## CITY OF RIALTO CONTRACT CHANGE ORDER

Date: 03/10/2020  
Project No: 170808  
Project: Metrolink Parking Lot Expansion  
Project Phase 2

Change Order No: 01  
Purchase Order No: 2019-1288  
Account Number(s): 223-500-4408-3001-170808-05

CITY OF RIALTO		
METROLINK PARKING LOT EXPANSION - PHASE 2		
GRADING & DRAINAGE PLAN - SHEET 1		
FOR: CITY OF RIALTO	CITY PROJECT NO. 170808	PLAN No. _____

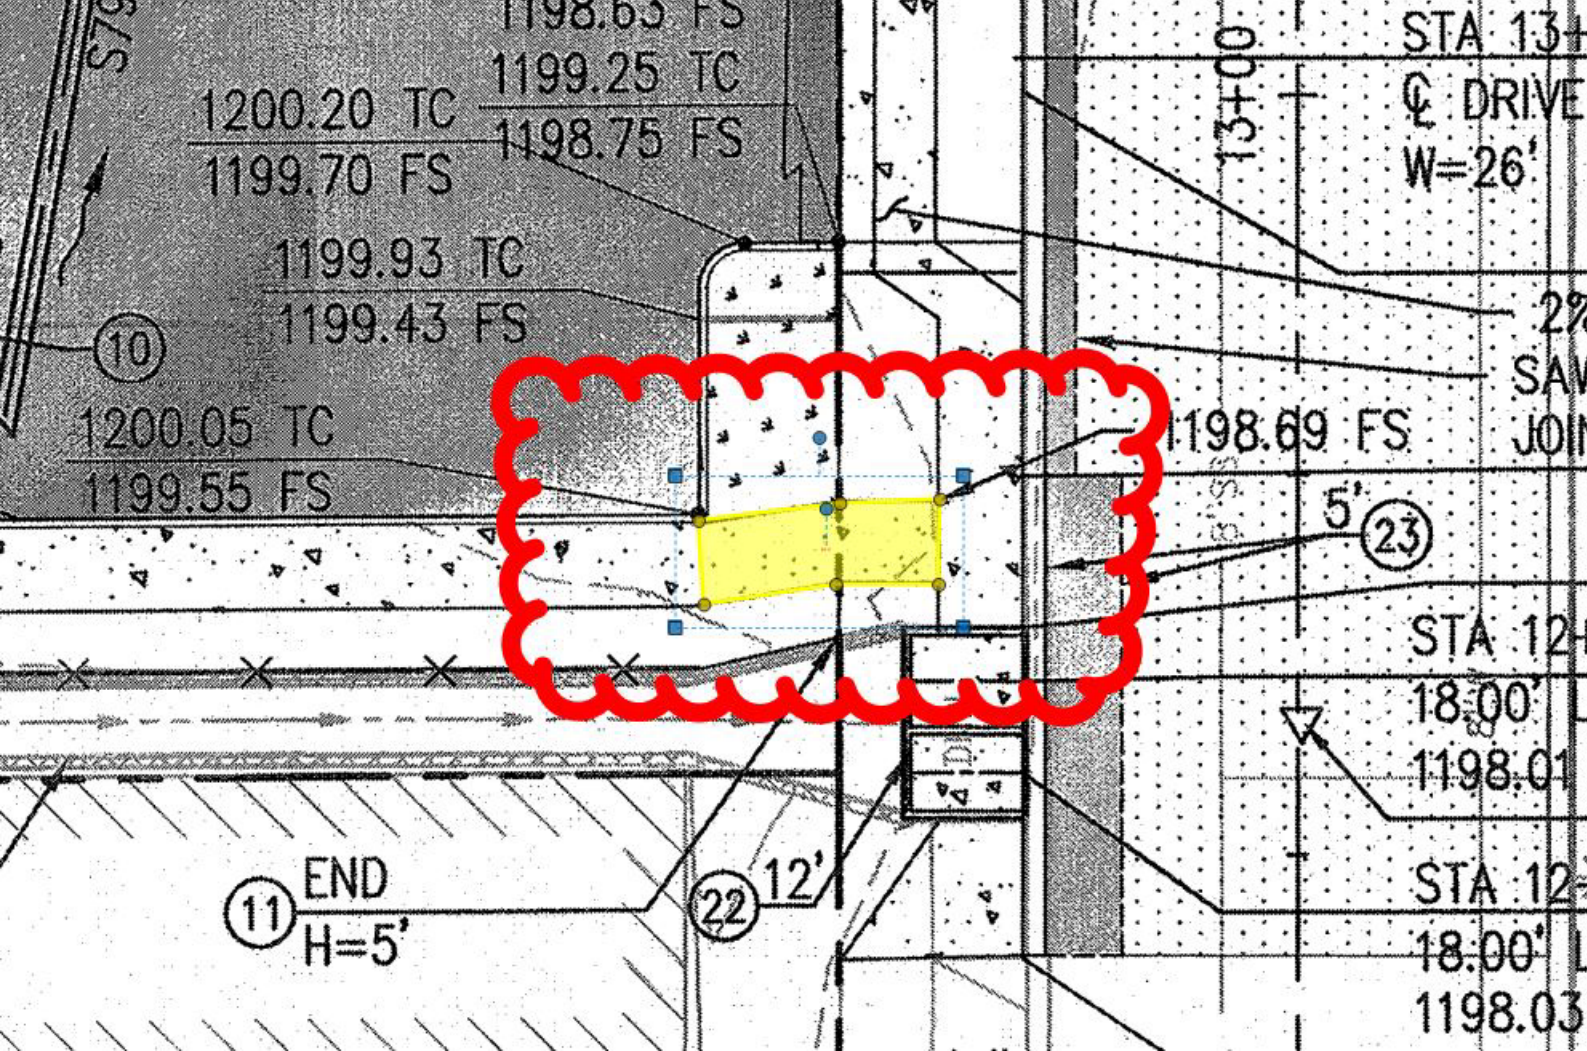
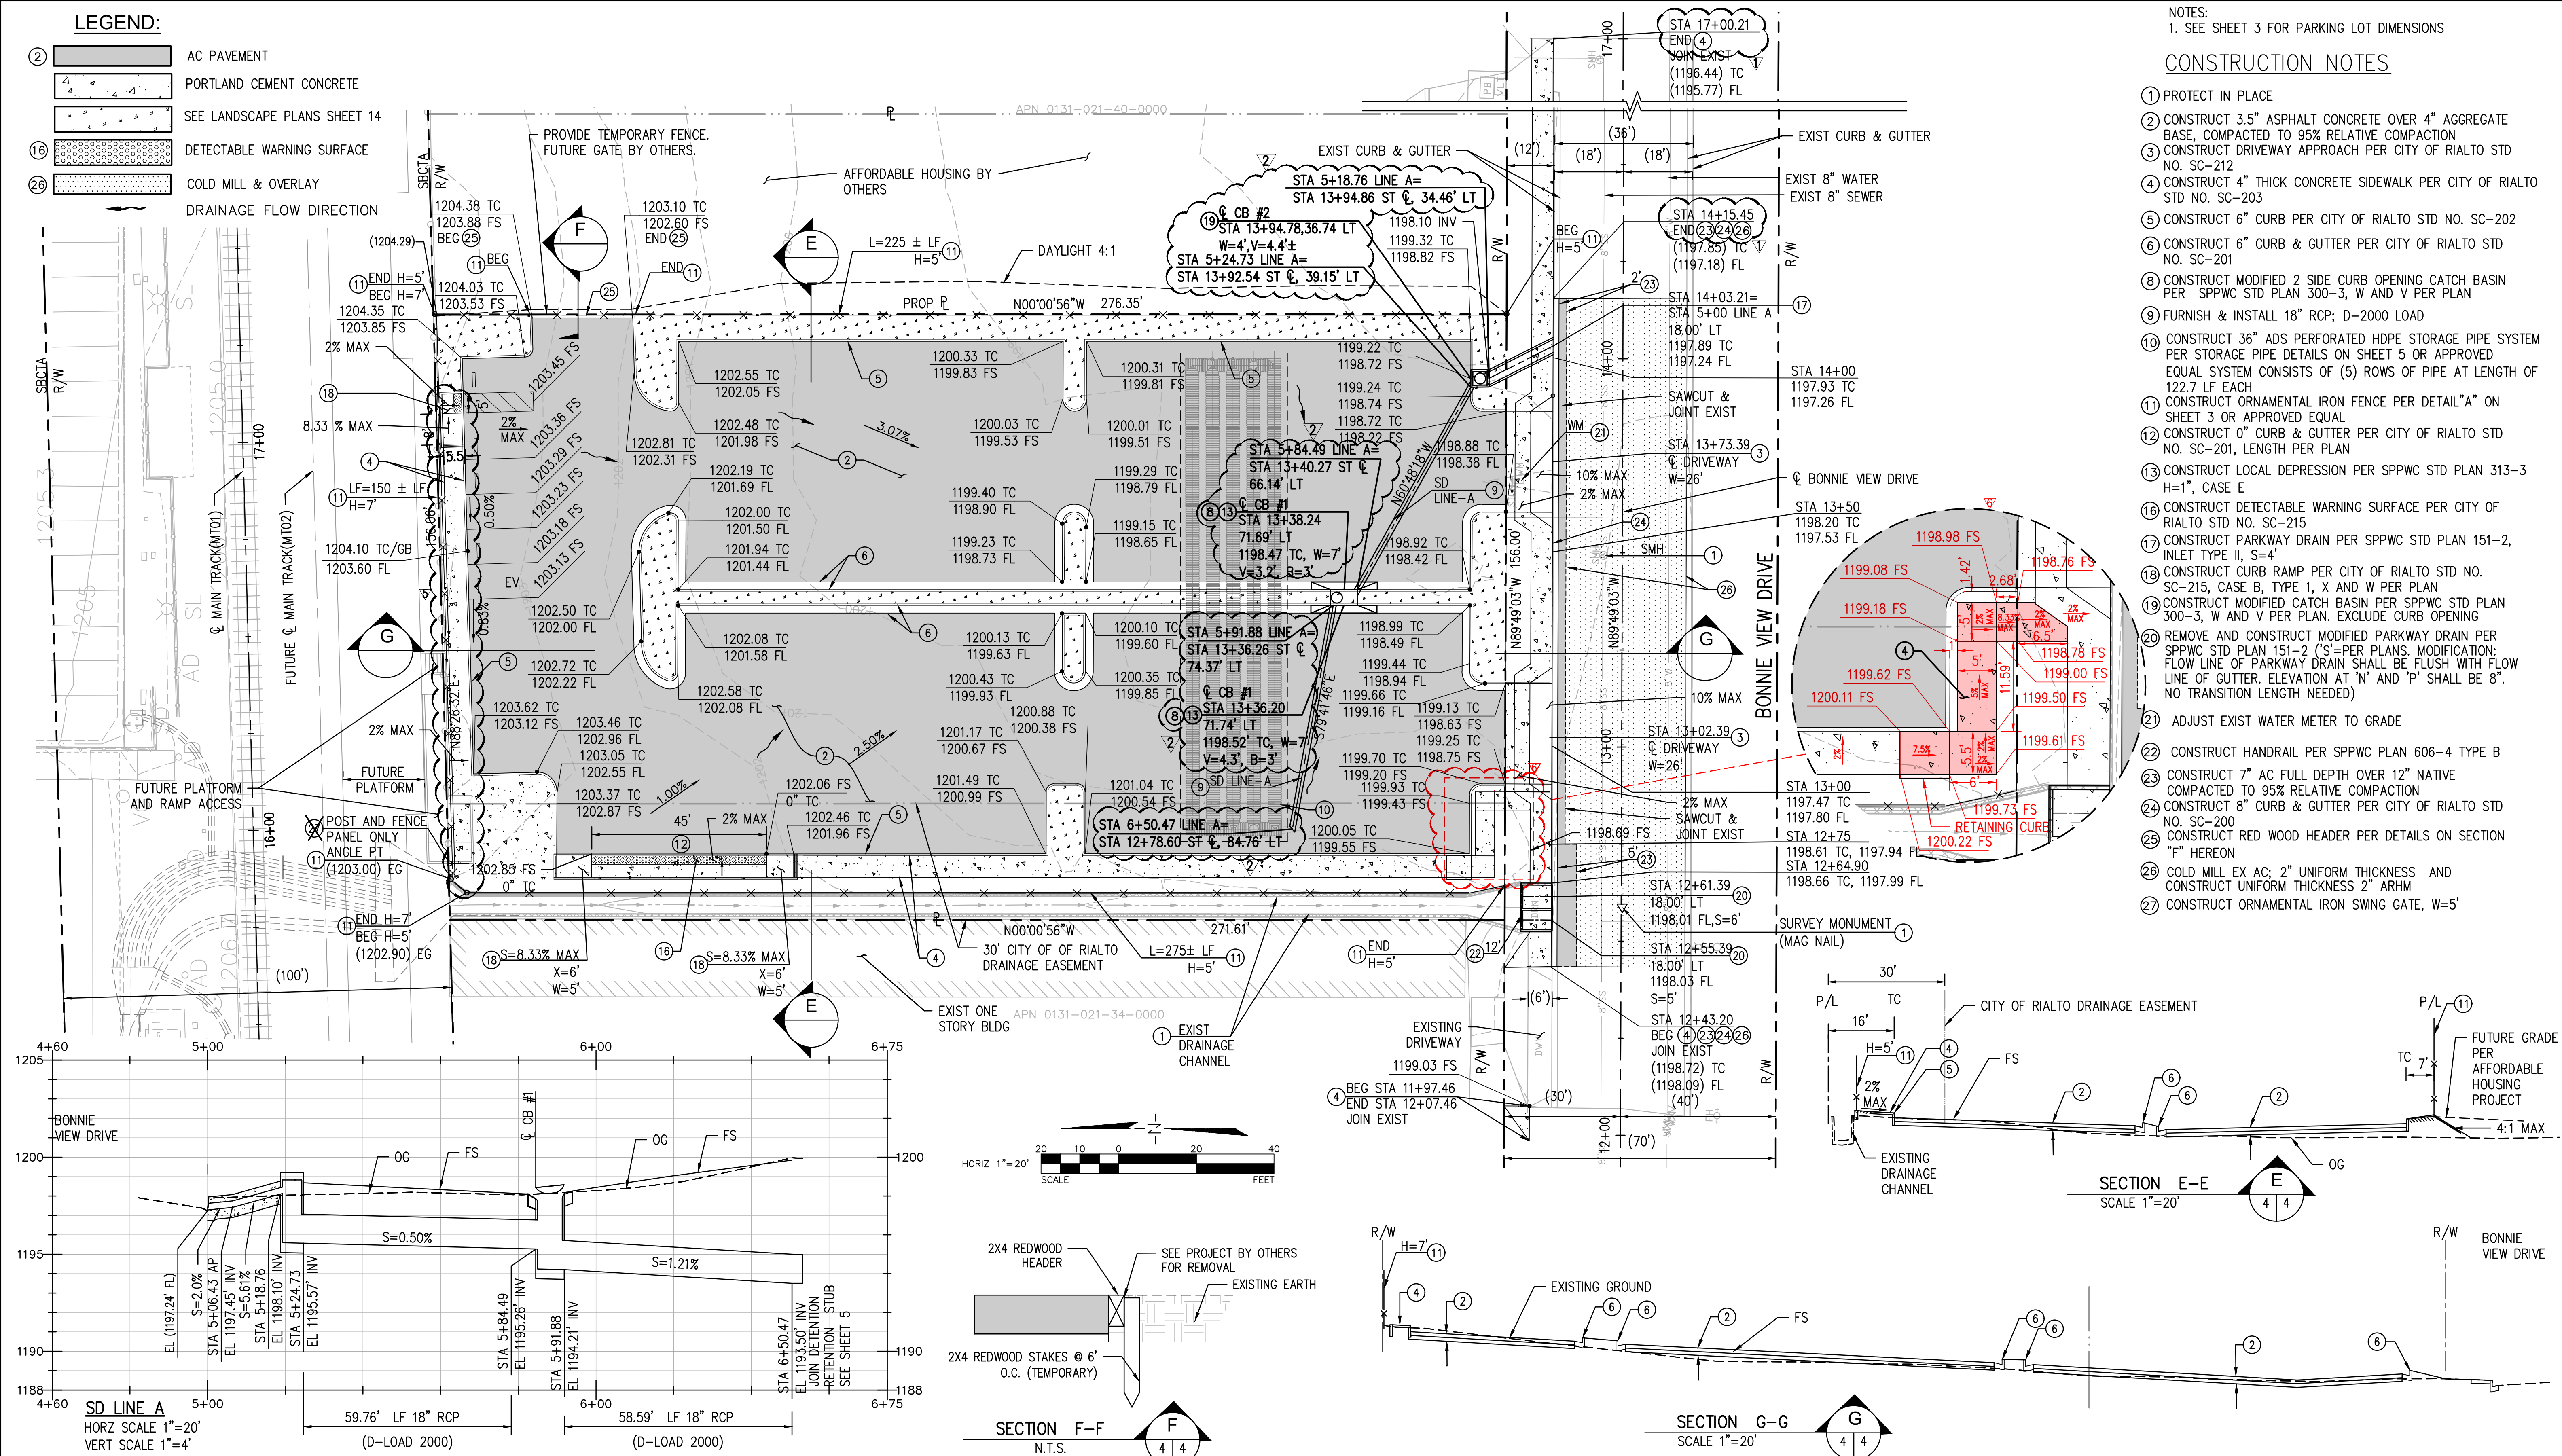
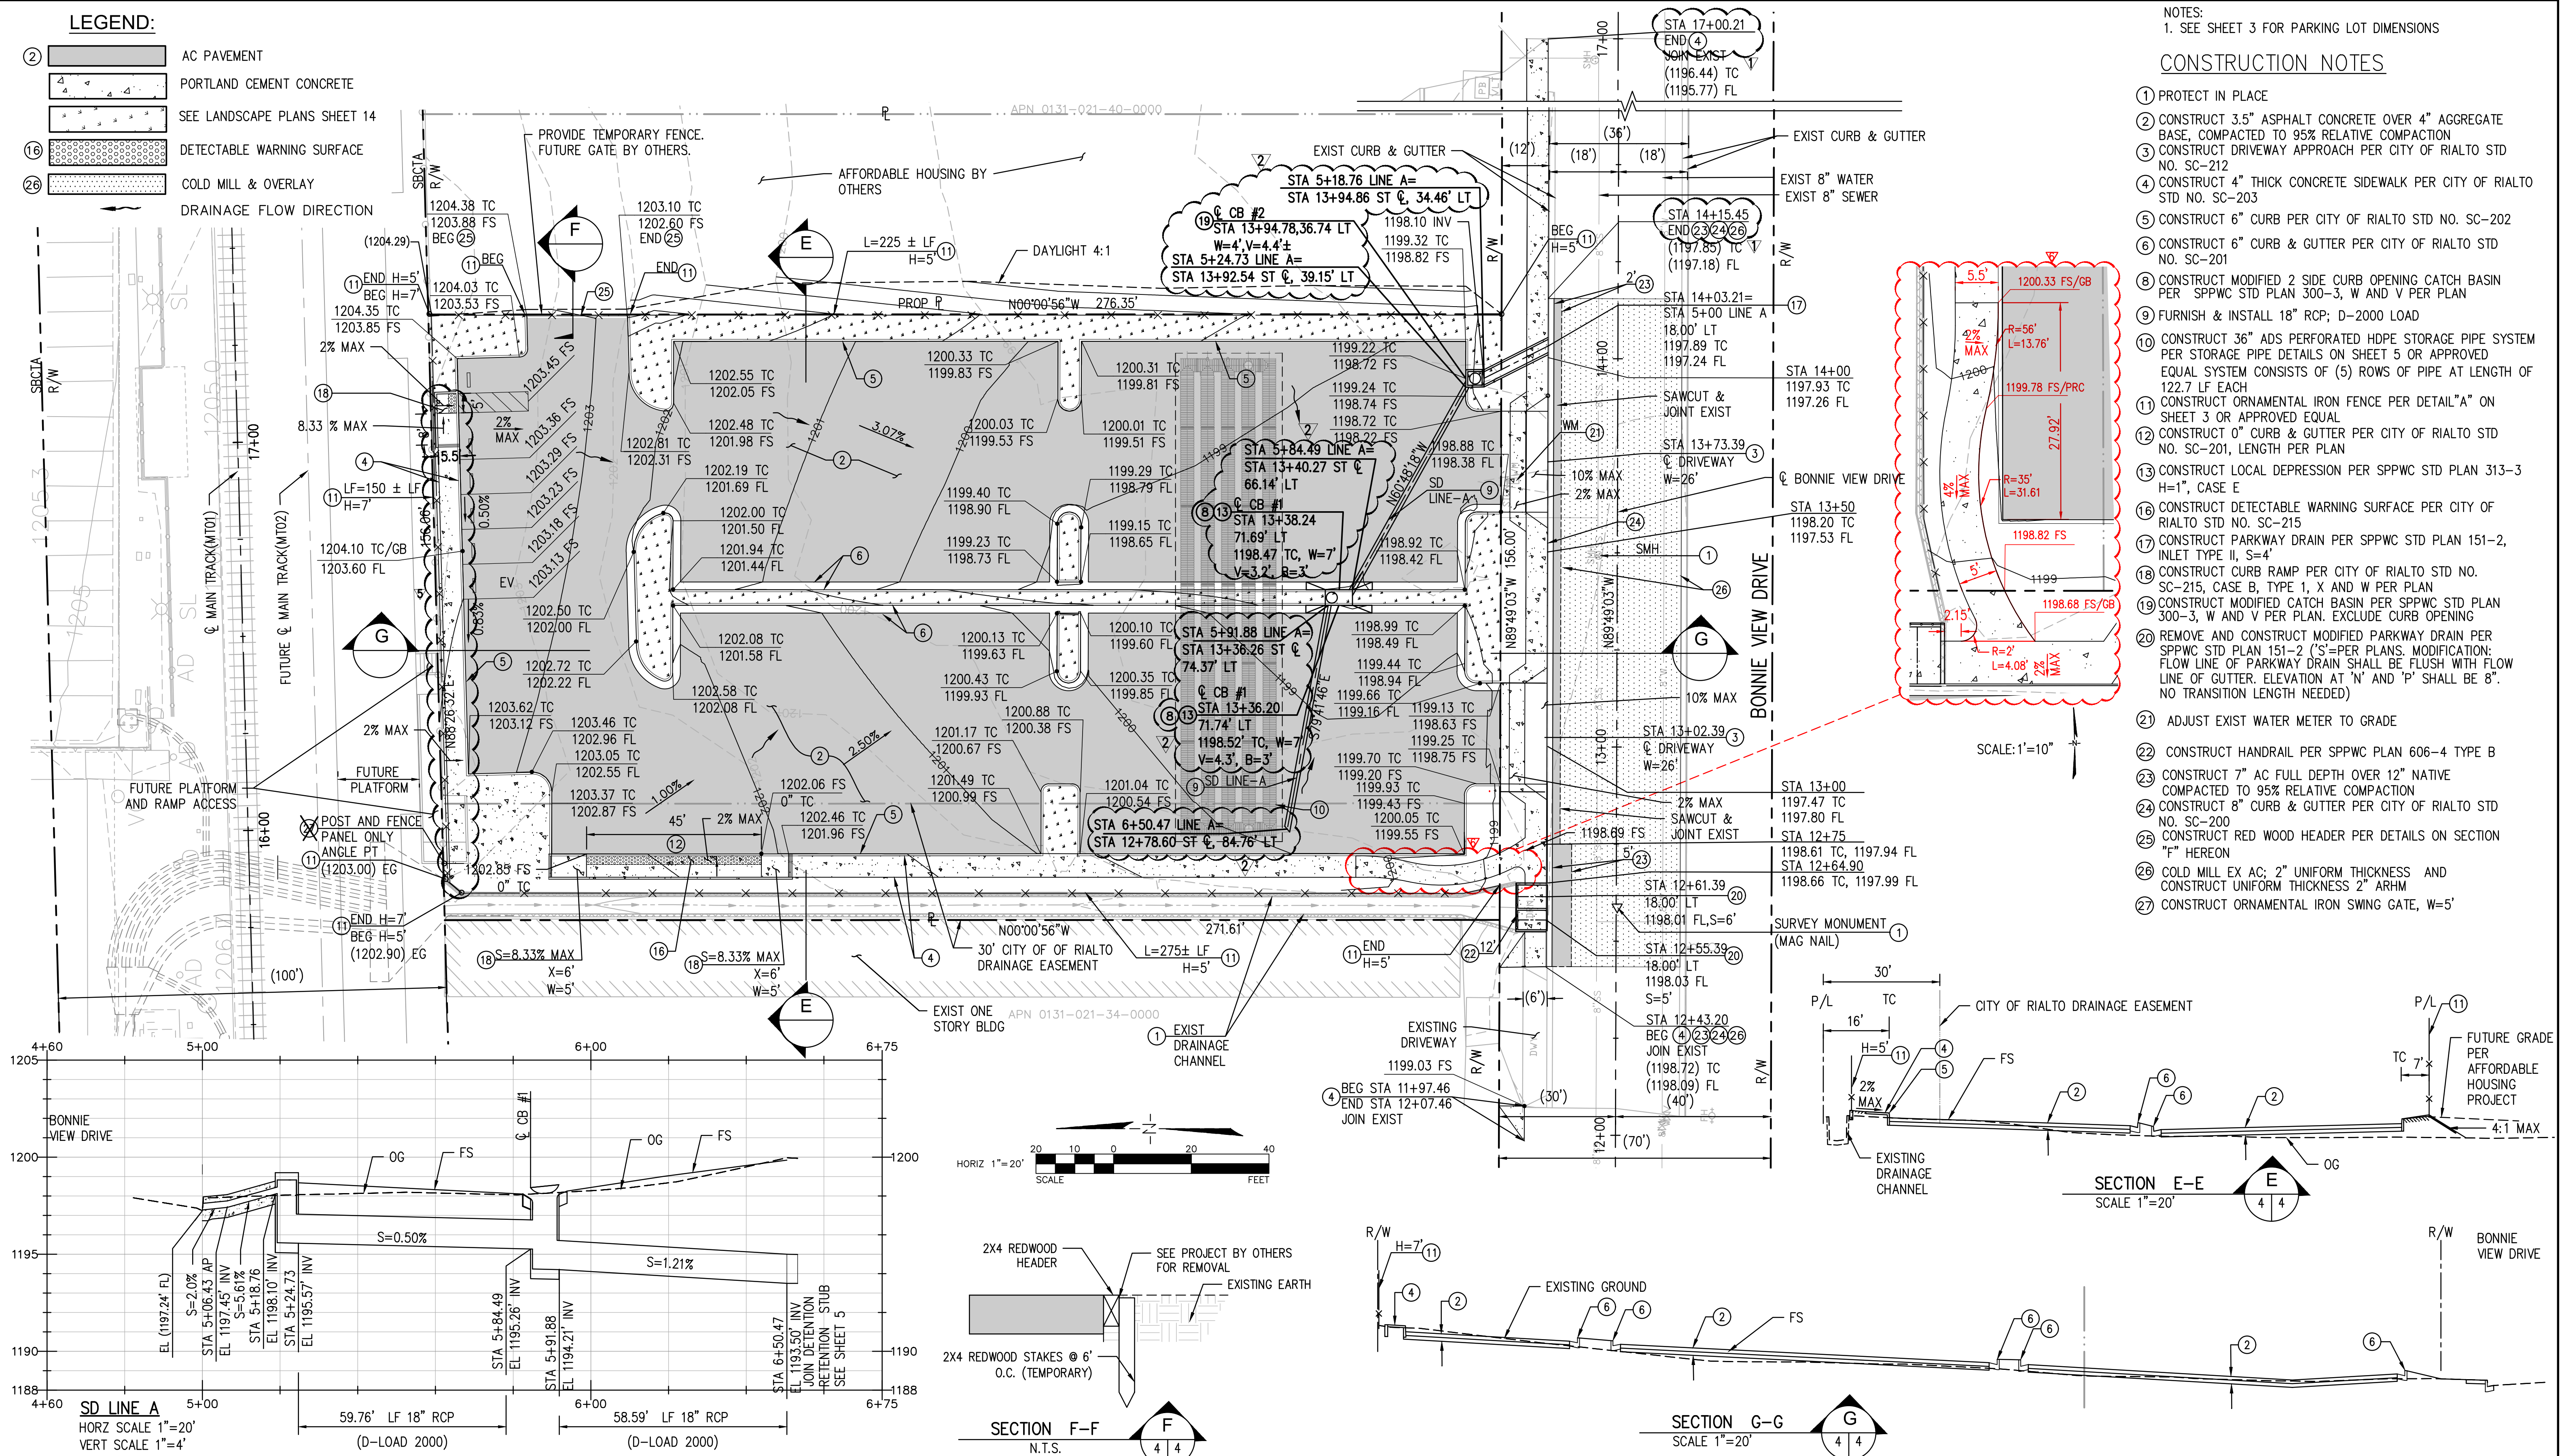
Please see attached sketch from sheet 4. The slope of the sidewalk is over 8% in the highlighted area. If this is a ADA path of travel, the slope would be too steep. Please confirm if we are ok to pour concrete sidewalk per plan.

See revised plan, attached.
